Project	IEEE 802.16 Broadband Wireless Access Working Group < http://ieee802.org/16 >		
Title	Addressing the missing MAC functions in 16m Relay (Section 15.6)		
Date Submitted	2009-11-06		
Source(s)	Rakesh Taori, Jicheol Lee, Heewon Kang, Hokyu Choi, Hyunjeong Kang, Jungshin Park, Jack Jang, Youngkyo Baek, Jung Je Son, MingXia Xu Samsung Electronics Company, 416, Maetan-3 dong, Yeongtong Gu Suwon, South Korea. 443-742.	Contact	rakesh.taori@samsung.com jicheol.lee@samsung.com hkang@samsung.com
Re:			
Abstract	This document analyzes the different solutions that are possible for relay. The document argues that whether a function should be located in the ARS or the ABS should be decided on the basis of performance (overhead, latency).		
Purpose			
Notice	<i>This document does not represent the agreed views of the IEEE 802.16 Working Group or any of its subgroups. It represents only the views of the participants listed in the "Source(s)" field above. It is offered as a basis for discussion. It is not binding on the contributor(s), who reserve(s) the right to add, amend or withdraw material contained herein.</i>

Addressing the missing MAC functions in 16m Relay (Section 15.6)

Figure xxx – Call flow for idle mode entry in the relay cell

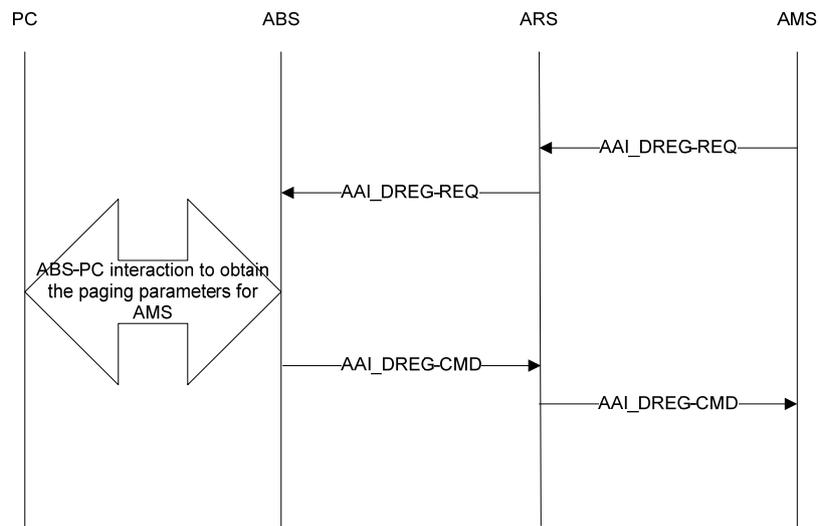
If the idle mode functions are managed at the ABS, the access ARS shall relay the AAI_DREG-REQ/CMD message between the ABS and the AMS. An operation of idle mode entry with an ARS involved is shown in Figure xxx.
